Summary of Modifications/Changes in this Update

U.S. Department of Veterans Affairs ♦ Office of Construction & Facilities Management

DATE OF THIS VERSION:

PHARMACY SERVICE WINDOW AND PACKAGE TRANSFER

PHARMACY SERVICE WINDOW AND PACKAGE TRANSFER

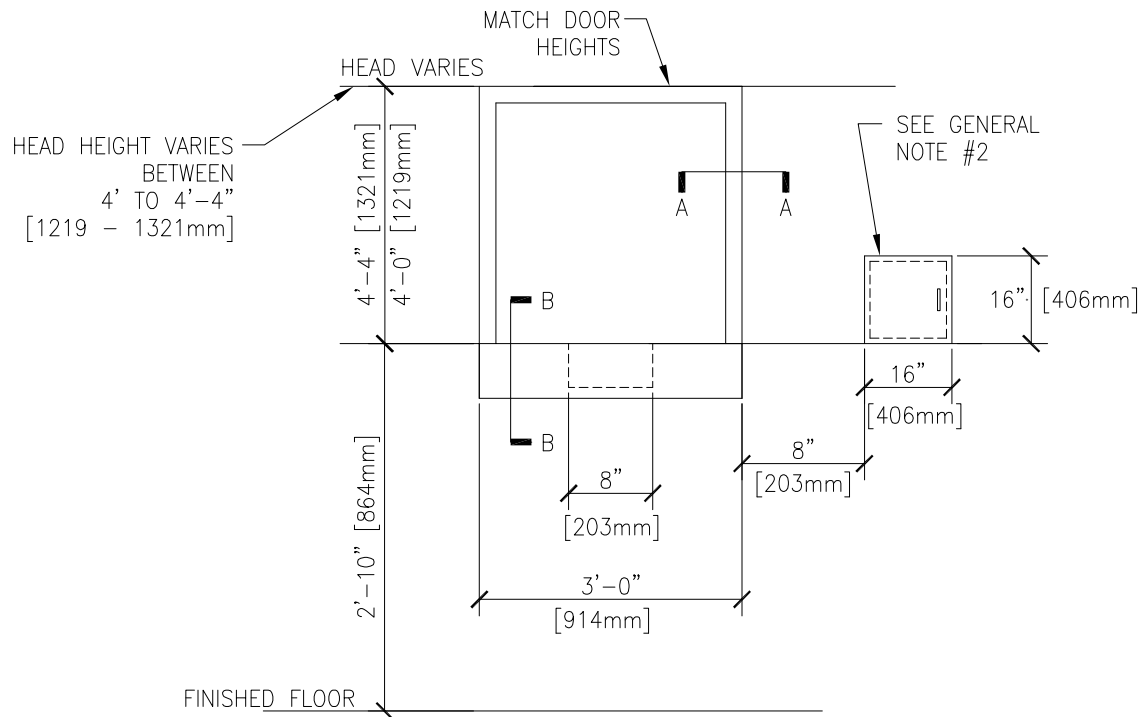
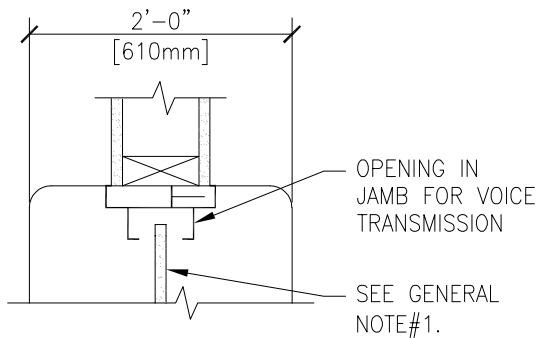
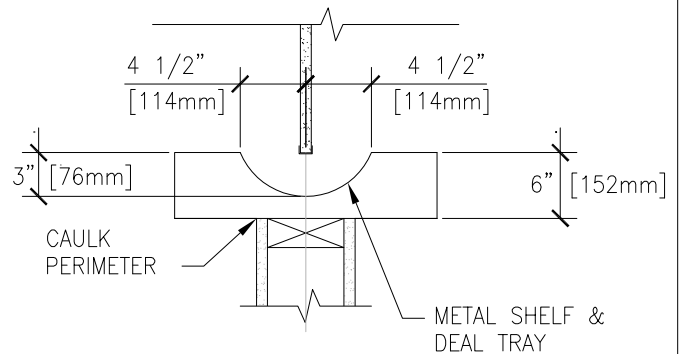
1. Revised General Note 1 to reference Physical Security and Resiliency Design Manual for dispensing partitions and openings requirements. Removed CMU from Section A and Section B.

1. SEE PHYSICAL SECURITY AND RESILIENCY DESIGN MANUAL (SECTION 5.12 PHARMACY) FOR ADDITIONAL DISPENSING PARTITIONS AND OPENINGS REQUIREMENTS.
2. PROVIDE AN INTERLOCK ON PACKAGE TRANSFER DOORS SO THAT BOTH DOORS CANNOT BE OPEN AT THE SAME TIME.
